City of Boise
ADA Assessment

Appendix A - Fire Training Center

Report # TO21-B024

ID: 1359 **Facility:** Fire Training/Safety Building

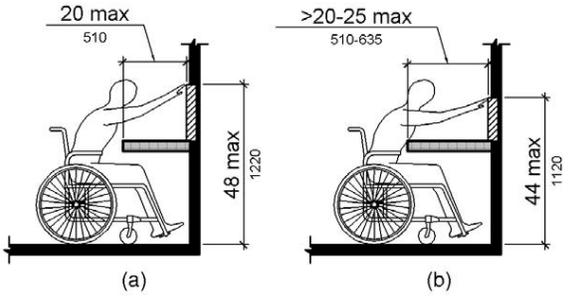
2010 ADA Standards for Accessible Design Codes §308.2.2
The soap dispenser is outside of the obstructed forward reach range at 48.5" above the floor.

Lower the soap dispenser by 0.5" to meet the accessible reach range of 48" maximum above the floor.

ID: 1360 **Facility:** Fire Training/Safety Building

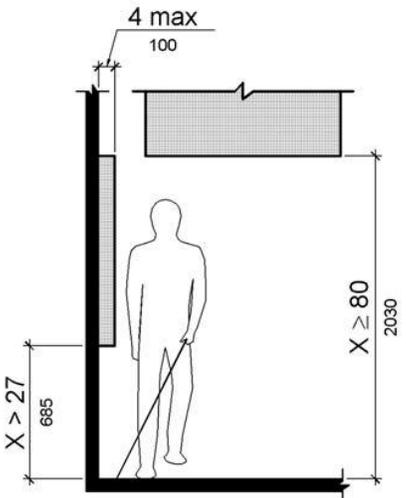
2010 ADA Standards for Accessible Design Codes §307.2
The AED protrudes 6" into the circulation space at 34" above the floor.

Recess the AED so it protrudes a maximum of 4", lower it so the bottom edge is 27" maximum above the floor, or place a cane detectable object beneath it.

ID: 1357 **Facility:** Fire Training/Safety Building

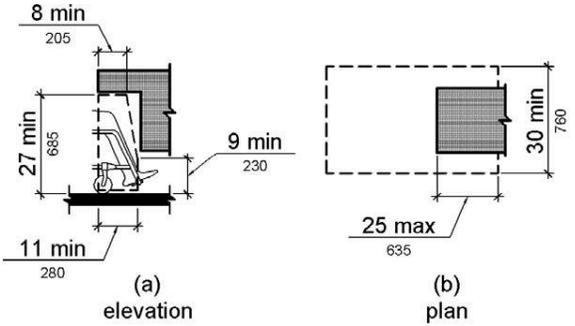
2010 ADA Standards for Accessible Design Codes §306.3.3
There is no knee clearance underneath the sink.

Provide knee clearance underneath the counter at the sink that is a minimum of 11" deep at 9" above the floor and 8" deep at 27" above the floor.

ID: 1361 **Facility:** Fire Training/Safety Building

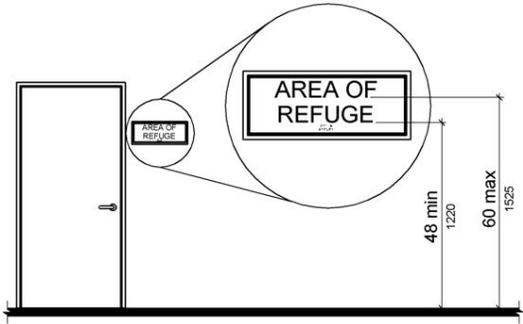
2010 ADA Standards for Accessible Design Codes §216.4, §703
Doors serving as exits are not marked by tactile signage.

Place a tactile exit sign, that complies with §703.1, §703.2 and §703.5, identifying the exit doors.
Install missing signage at 48" minimum above the floor measured from the baseline of the lowest character and 60" maximum measured from the baseline of the highest character.

ID: 1300 **Facility:** Fire Training/Safety Building

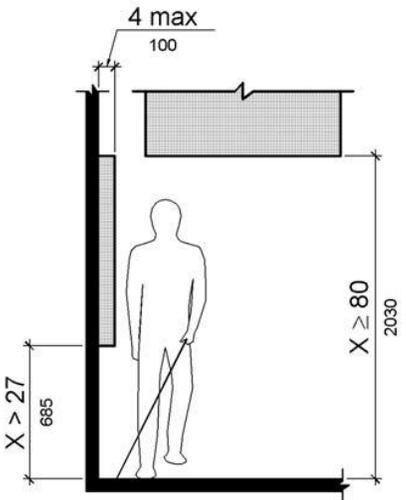
2010 ADA Standards for Accessible Design Codes §307.2
The TV protrudes 6" into the circulation space at 45.5" above the floor.

Recess the TV so it protrudes a maximum of 4" or place a cane detectable object beneath it.

ID: 1295
Facility: Fire Training/Safety Building

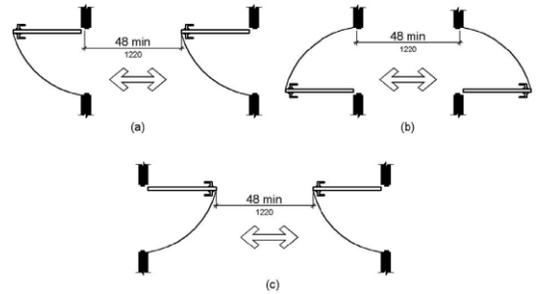
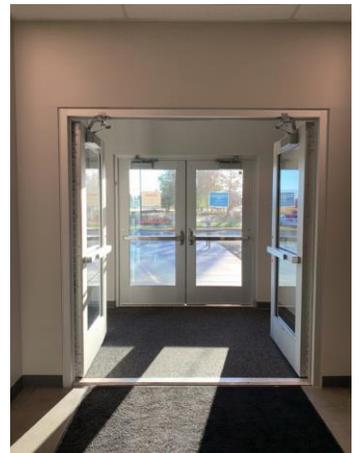
Between the two hinged or pivoted doors, the width is 46".

Remove the inside set of doors or reverse the swing of the inside set of doors.

ID: 1299 **Facility:** Fire Training/Safety Building

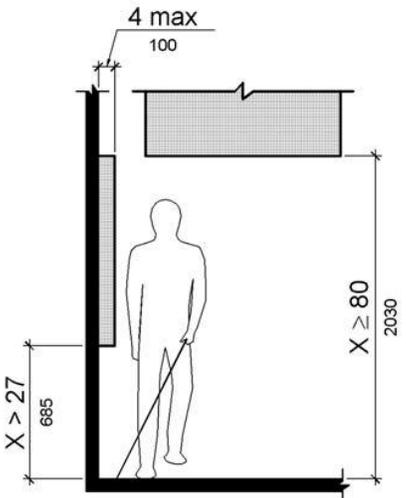
2010 ADA Standards for Accessible Design Codes §307.2
The gas tanks protrude 6.5" into the circulation space at 28" above the floor.

Recess the gas tanks so they protrude a maximum of 4", lower them so the bottom edge is 27" maximum above the floor, or place a cane detectable object beneath them.

ID: 1315 **Facility:** Fire Training/Safety Building

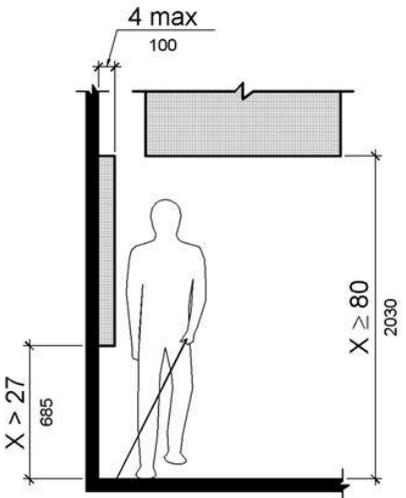
2010 ADA Standards for Accessible Design Codes §307.2
The AED protrudes 6" into the circulation space at 34" above the floor.

Recess the AED so it protrudes a maximum of 4", lower it so the bottom edge is 27" maximum above the floor, or place a cane detectable object beneath it.

ID: 1279 **Facility:** Fire Training/Safety Building

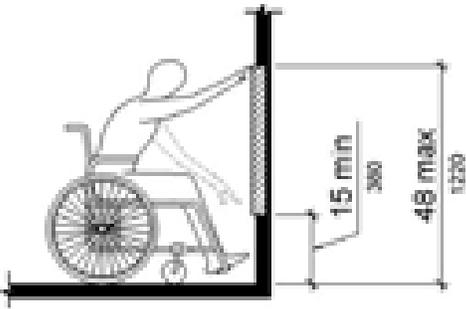
2010 ADA Standards for Accessible Design Codes §308.2.1
The badge scanner is outside of the unobstructed forward reach range at 52" above the floor.

Lower the badge scanner by 4" to meet the accessible reach range of 48" maximum above the floor.

ID: 1280 **Facility:** Fire Training/Safety Building

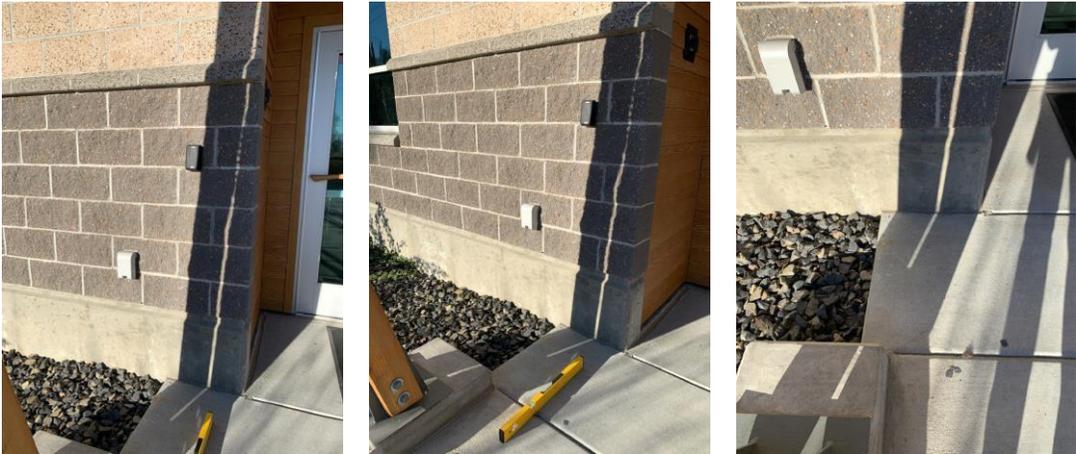
The clear floor space to access the card scanner at the main entrance is not large enough.

Expand the clear floor space to be 30"x48" with a maximum slope of 2% in all directions.

ID: 1316 **Facility:** Fire Training/Safety Building

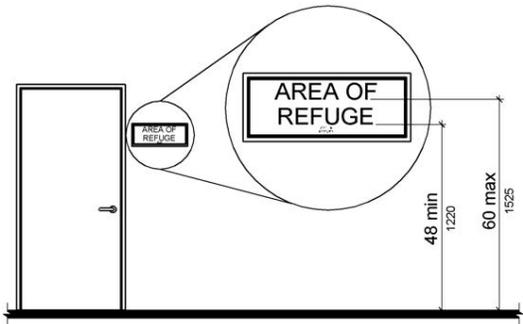
2010 ADA Standards for Accessible Design Codes §216.2, §703
Throughout the Fire Department buildings, there are no tactile signs identifying 36 permanent rooms.

Install tactile signage on the latch side of the doorway at a height of 48” minimum to 60” maximum above the floor, identifying room by name or room number.
Signs shall be Braille with raised lettering and should be placed on the wall in the center of an 18"x18" clear floor space.

ID: 1276 **Facility:** Fire Training/Safety Building

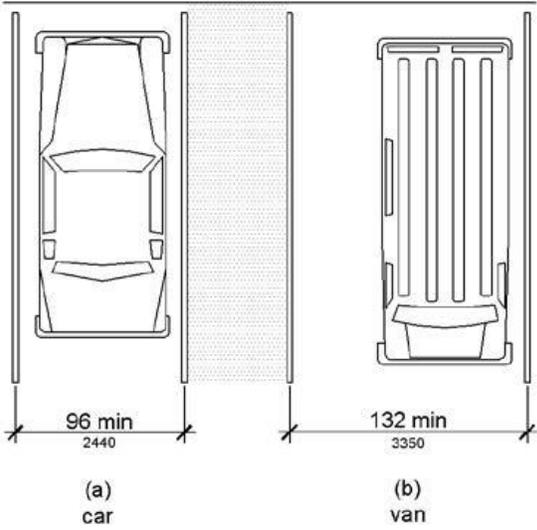
2010 ADA Standards for Accessible Design Codes §208.2.4, §502
There are no painted lines on the left side of the accessible parking space and ISA symbols are fading.

Stripe the left side of the accessible parking space and repaint the ISA symbols.

ID: 1343 **Facility:** Fire Training/Safety Building

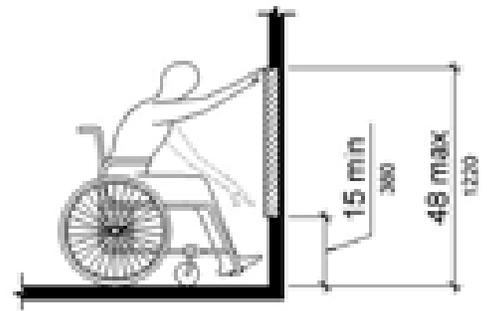
2010 ADA Standards for Accessible Design Codes §308.2.1
The hook is outside of the unobstructed forward reach range at 64" above the floor.

Lower the hook by 16" to meet the accessible reach range of 48" maximum above the floor.

ID: 1348 **Facility:** Fire Training/Safety Building

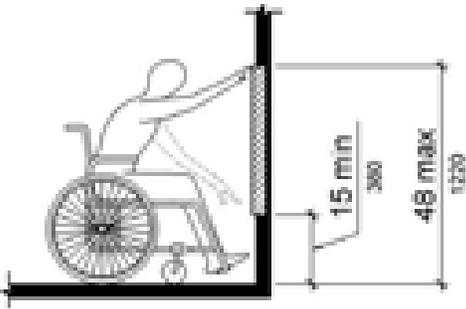
2010 ADA Standards for Accessible Design Codes §308.2.1
The soap dispenser is outside of the unobstructed forward reach range at 54" above the floor.

Lower the soap dispenser by 6" to meet the accessible reach range of 48" maximum above the floor.

ID: 1356 **Facility:** Fire Training/Safety Building

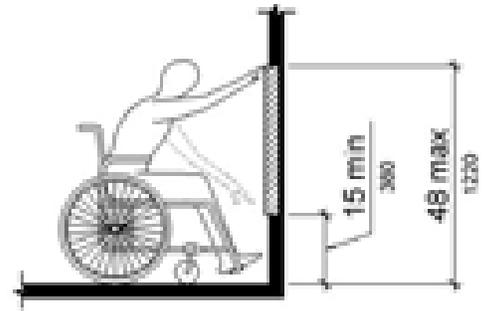
The hooks are outside of the unobstructed forward reach range at 64.5" above the floor.

Lower at least one of the hooks by 16.5" to meet the accessible reach range of 48" maximum above the floor.

ID: 1336 **Facility:** Fire Training/Safety Building

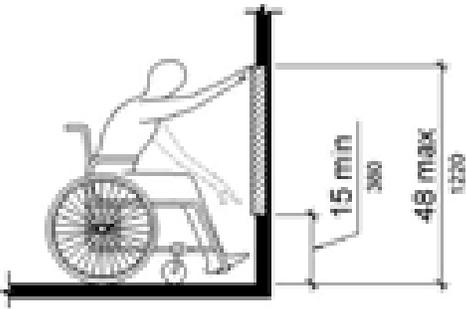
2010 ADA Standards for Accessible Design Codes §308.2.1
The soap dispenser is outside of the unobstructed forward reach range at 54" above the floor.

Lower the soap dispenser by 6" to meet the accessible reach range of 48" maximum above the floor.

ID: 1338 **Facility:** Fire Training/Safety Building

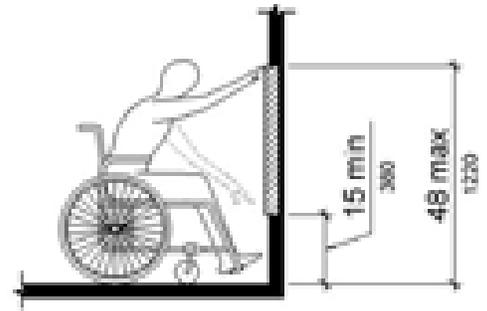
The hooks are outside of the unobstructed forward reach range at 64" above the floor.

Lower at least one of the hooks by 16" to meet the accessible reach range of 48" maximum above the floor.

ID: 1321 **Facility:** Fire Training/Safety Building

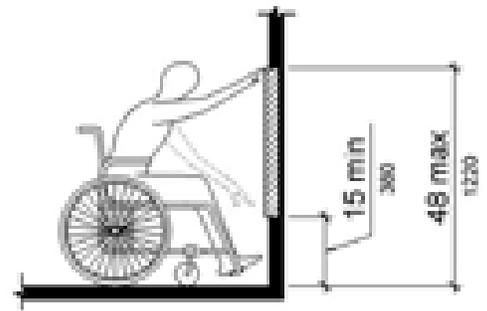
The hooks are outside of the unobstructed forward reach range at 64" above the floor.

Lower at least one of the hooks by 16" to meet the accessible reach range of 48" maximum above the floor.

ID: 1289 **Facility:** Fire Training/Safety Building

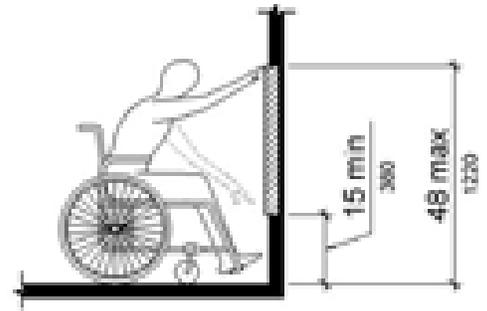
The hooks are outside of the unobstructed forward reach range at 64" above the floor.

Lower at least one of the hooks by 16" to meet the accessible reach range of 48" maximum above the floor.

ID: 1308 **Facility:** Fire Training Admin Building

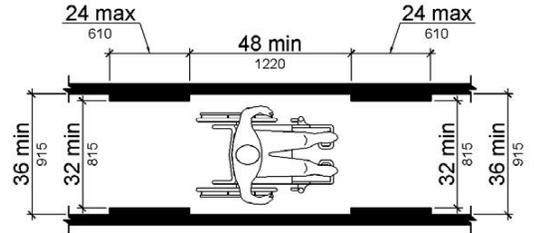
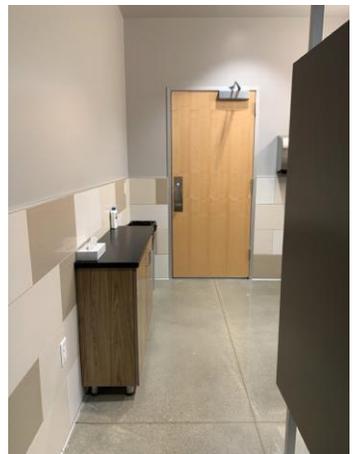
There is not a clear 36" width for wheelchairs to pass between the counter and the restroom door. When the restroom door is closed, the width is 29.5". When the restroom door is open, the width is 27.75".

Remove the counter from the restroom to ensure that there is a minimum clear width of 36".

ID: 1305 **Facility:** Fire Training Admin Building

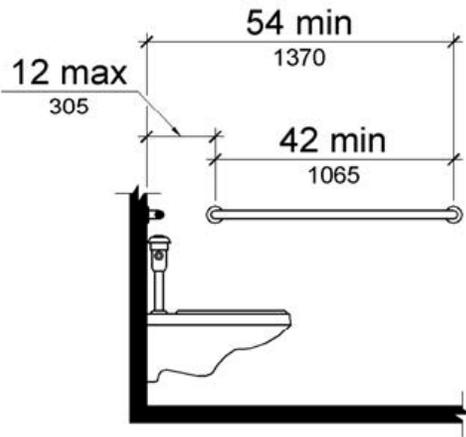
2010 ADA Standards for Accessible Design Codes §604.5.1
The side grab bar is located 11" from the rear wall, is 33" long, and extends 44.5" from the rear wall.

Replace the side grab bar with one that is a minimum of 42" long minimum, located 12" maximum from the rear wall and extending 54" minimum from the rear wall.
